RE: Change in Size of the Grimes Station Pad (97-AFC-02C)

Exhibit 1
Project Alignment
Grimes Pipeline Project
January 2011
Sheet 8 of 8

**Corrections and Clarifications
To the
Grimes Pipeline Project Amendment
To
Sutter Energy Center AFC-97-02**

PROPOSED TREE
REMOVAL

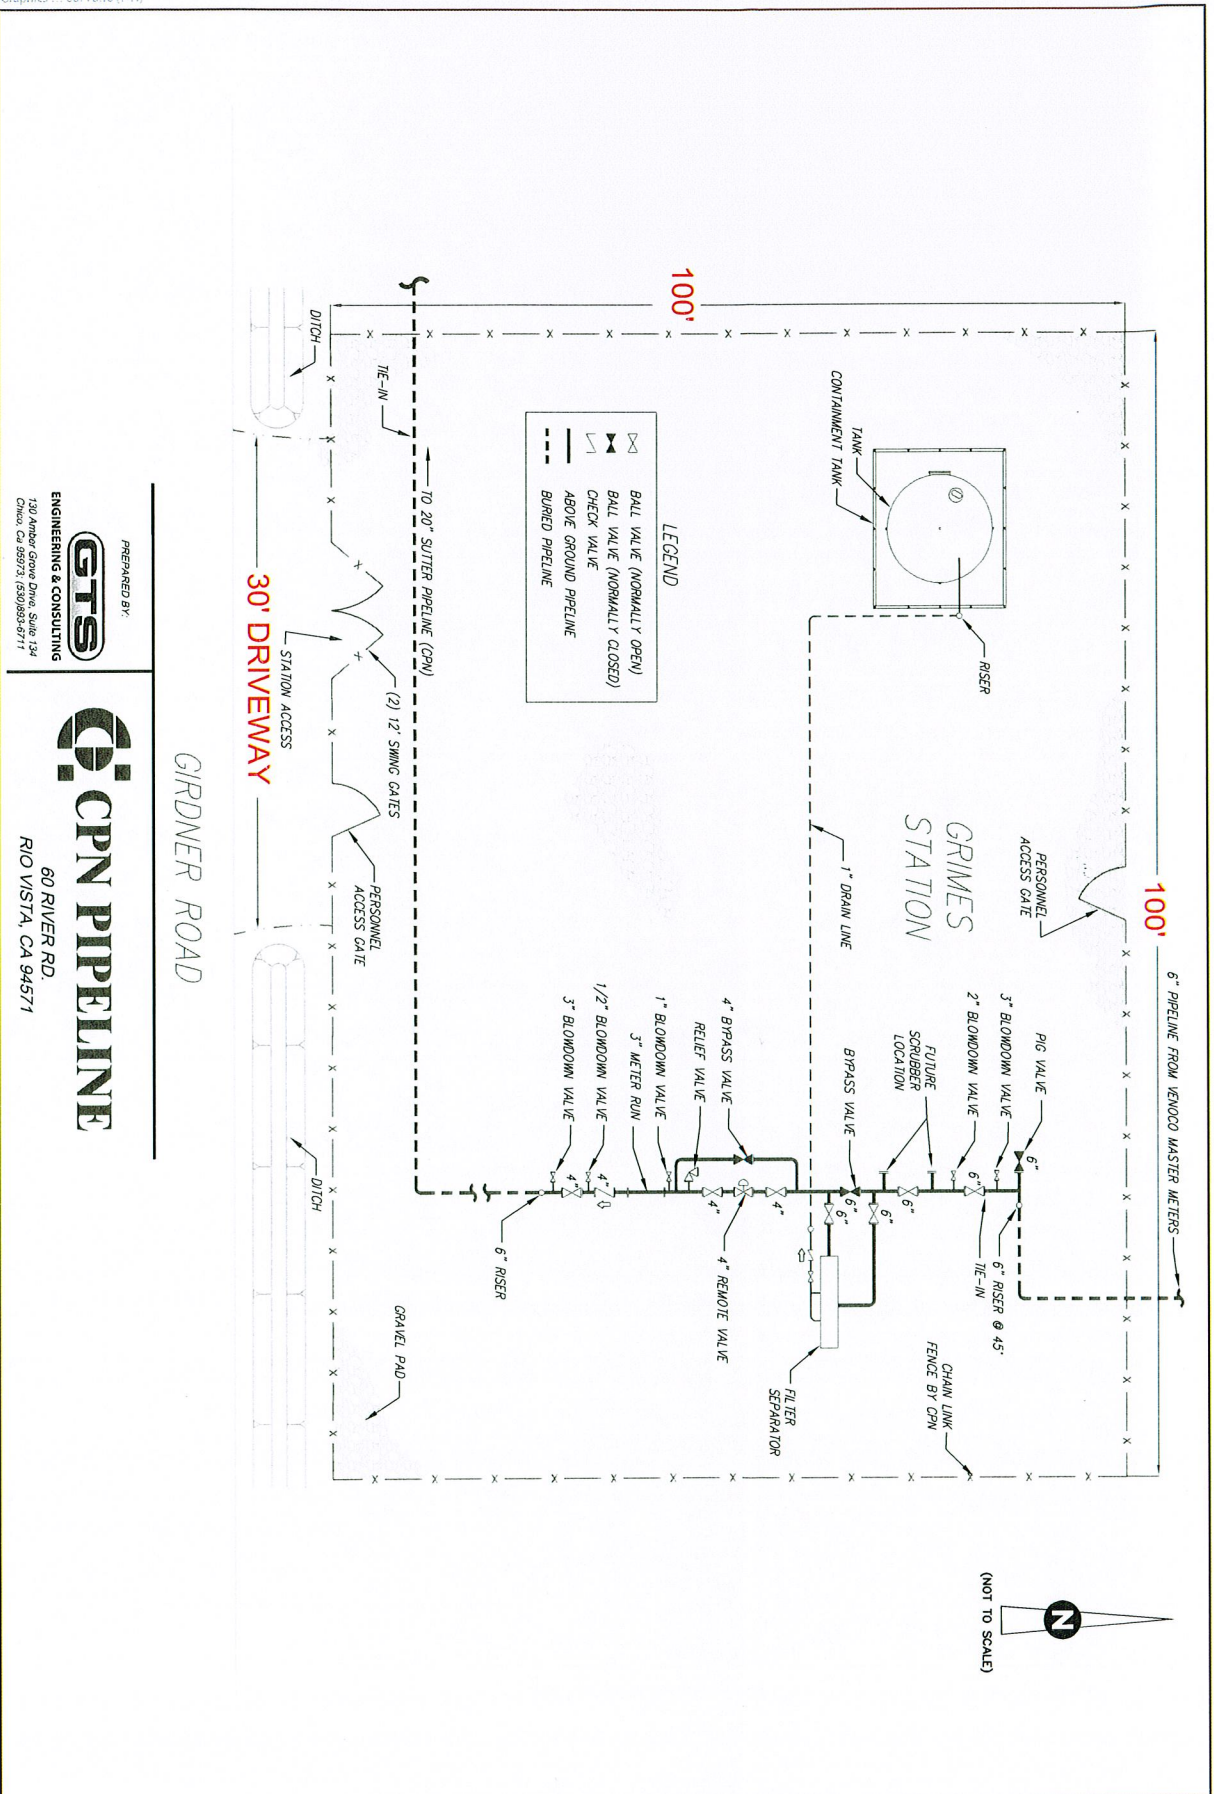
Several trees growing in the drainage ditch between Girdner Road and the Grimes Station pad site will be removed to accommodate the new location of the driveway. While the width of the entrance to the Grimes Station would be reduced, approximately 5 trees varying in height from about 3 to 10 feet (3 willows and 2 oaks) would be removed. See the attached photo for site conditions at the new entrance way. The removal of these trees is not a significant impact.

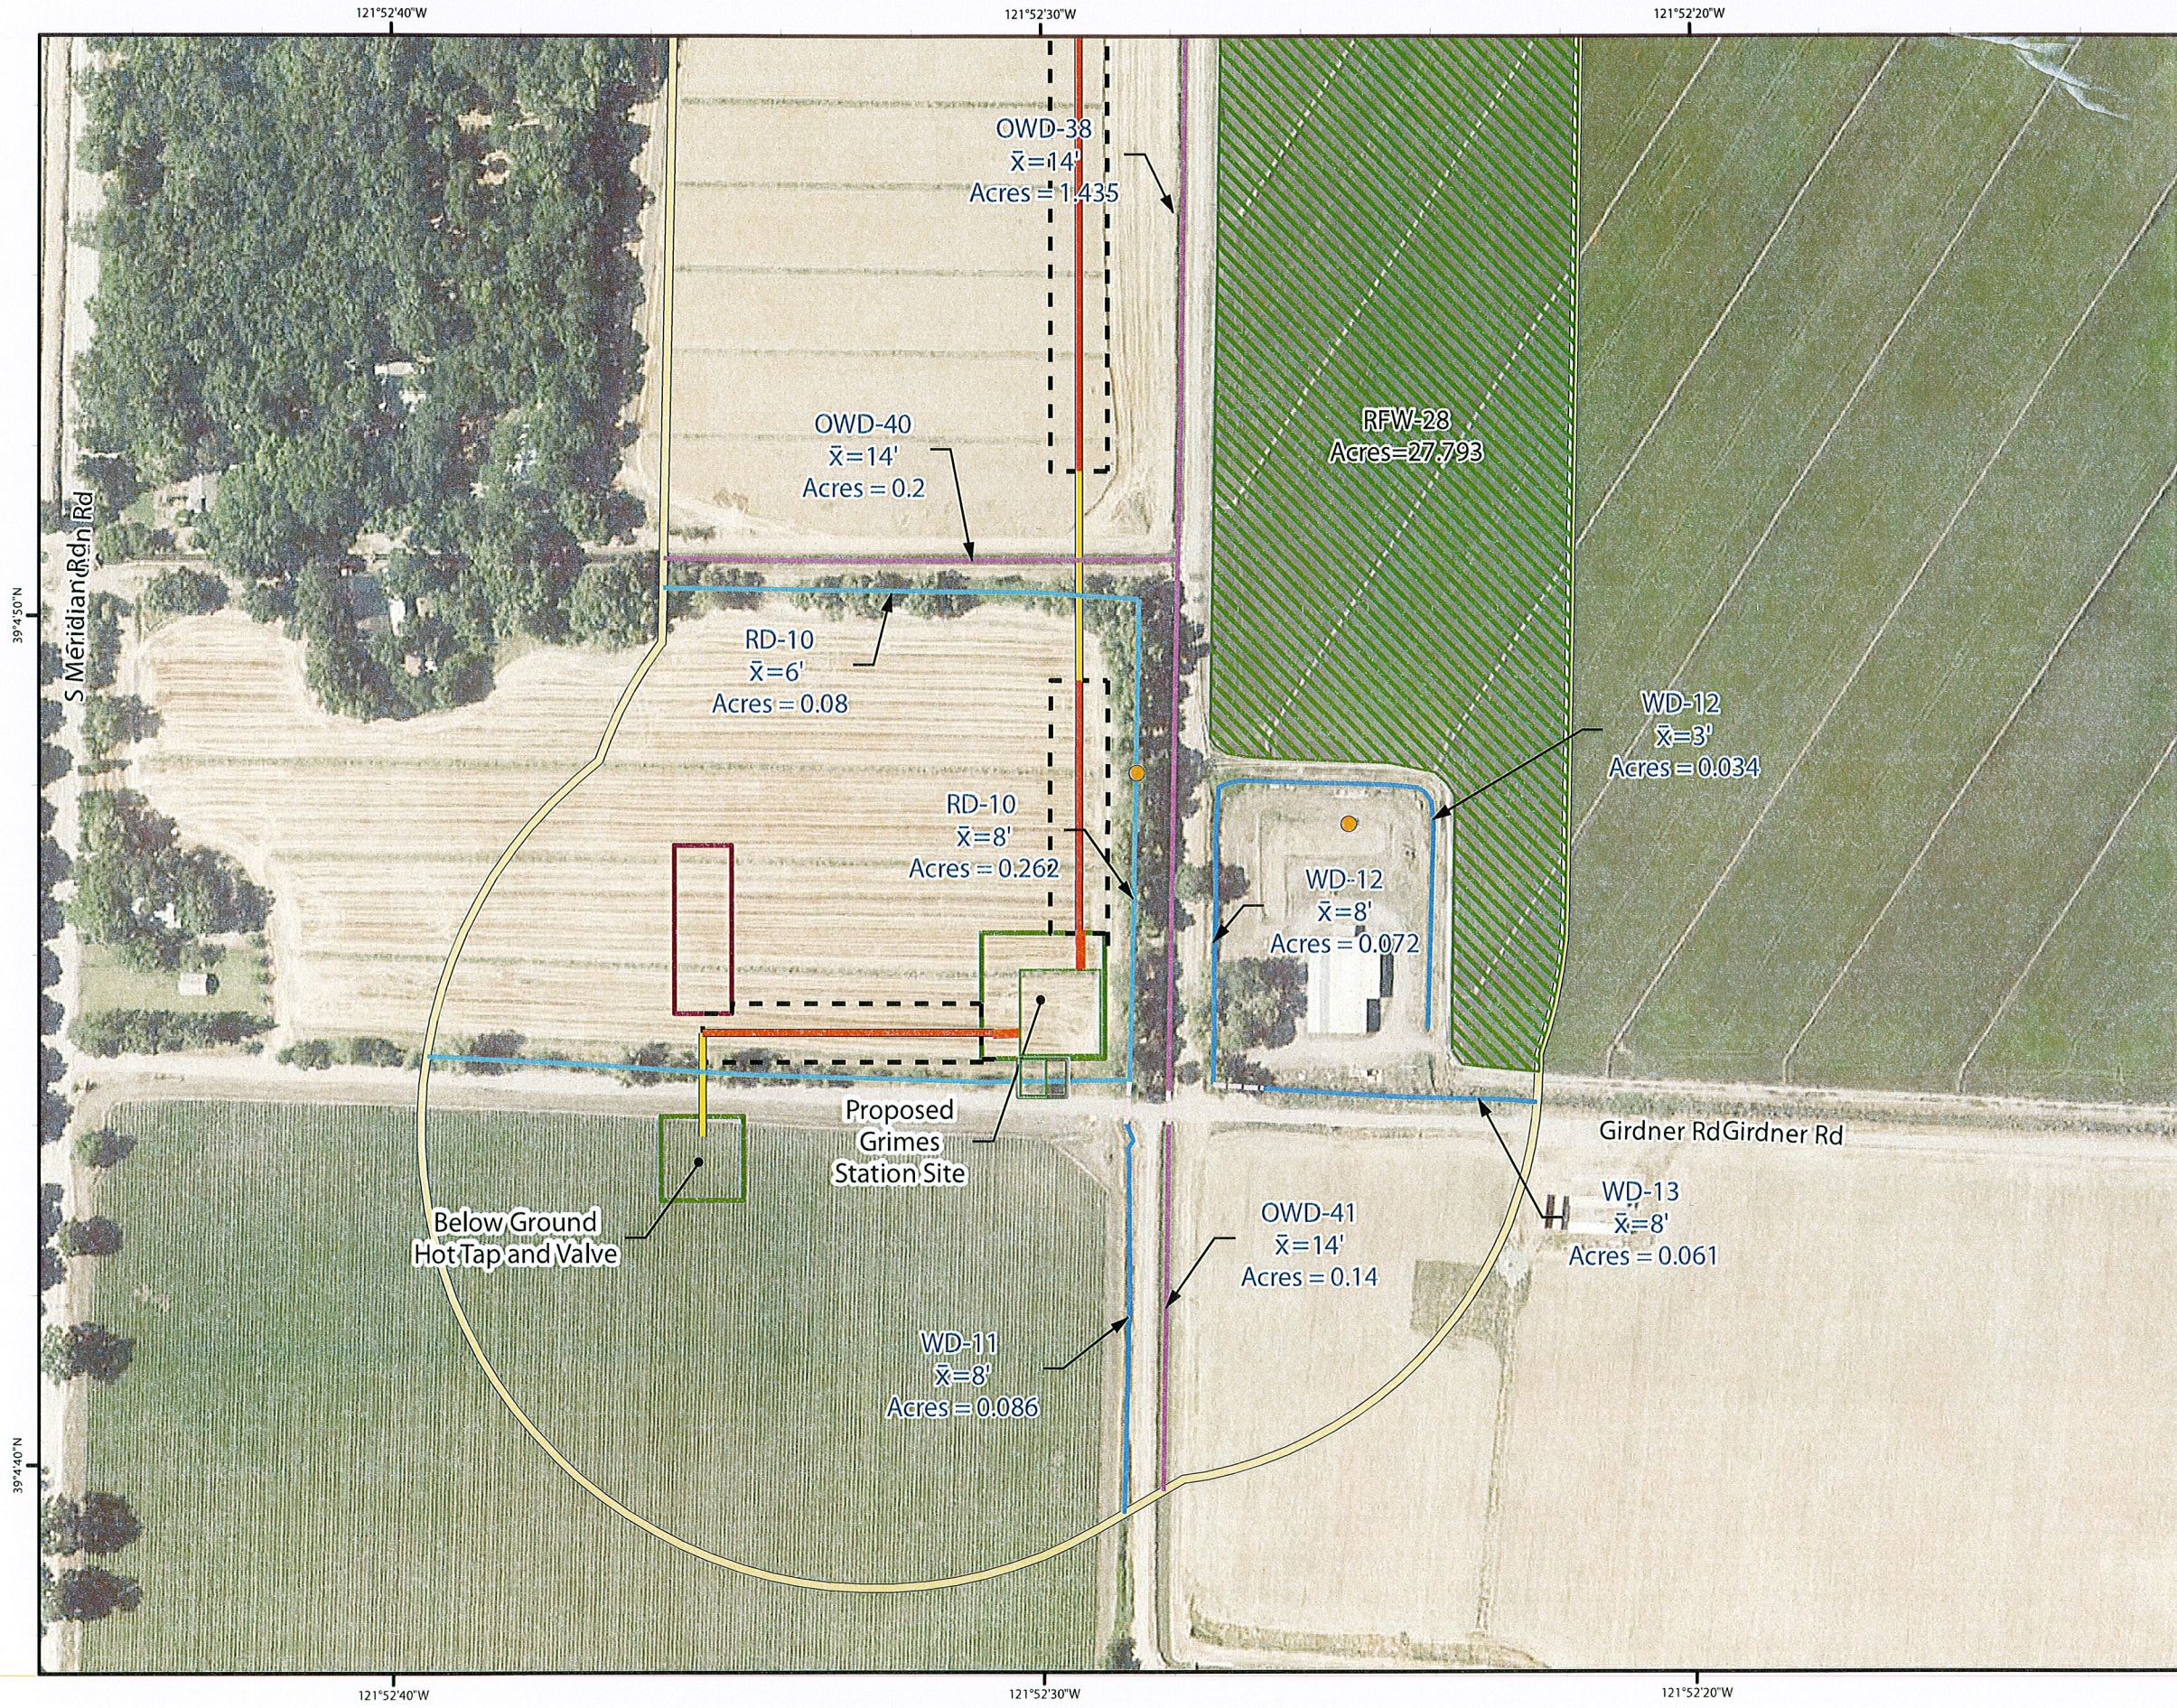
Calpine will reduce the size of the Grimes Station pad from 150 feet by 150 feet (as proposed in the Amendment) to 100 feet by 100 feet. The total area of the revised Grimes Station pad will be 0.22 acre. The entrance to the Grimes Station will be moved approximately 50 feet to the east of the original entrance location. The entrance way will be reduced in width from 60 feet to 30 feet. There will be no change in the scope of the facilities at the Grimes Station, although the facilities will be configured closer together and with this change there will be less underground piping. See the attached revised Figure 2 for the revised facilities layout. The temporary construction footprint for the Grimes Station will remain at 0.8 acre.

15	Appendix A Project Alignment Sheets.	Sheet 8	Replace with revised Sheet 8 (attached)
16	Appendix C Biological Resources Study Report, Page 16, first paragraph, first sentence.	The 0.5 acre Grimes Station site is within and adjacent to habitats that provided foraging and...	The 0.22 acre Grimes Station site is within and adjacent to habitats that provided foraging and...
17	Appendix C Biological Resources Study Report, Page 16, second paragraph, second sentence.	In addition, the 0.5 acre of row crop that will be removed to construct the Grimes Station is considered small....	In addition, the 0.22 acre of row crop that will be removed to construct the Grimes Station is considered small....
18	Appendix C, page 19, Cumulative Effects	However, the proposed Project will convert approximately 0.5 acre of row crop to industrial development.	However, the proposed Project will convert approximately 0.22 acre of row crop to industrial development.

19	Appendix E Biological Assessment, Exhibit 1 Project Alignment Sheets	Sheet 8	Replace with revised Sheet 8 (Attached)
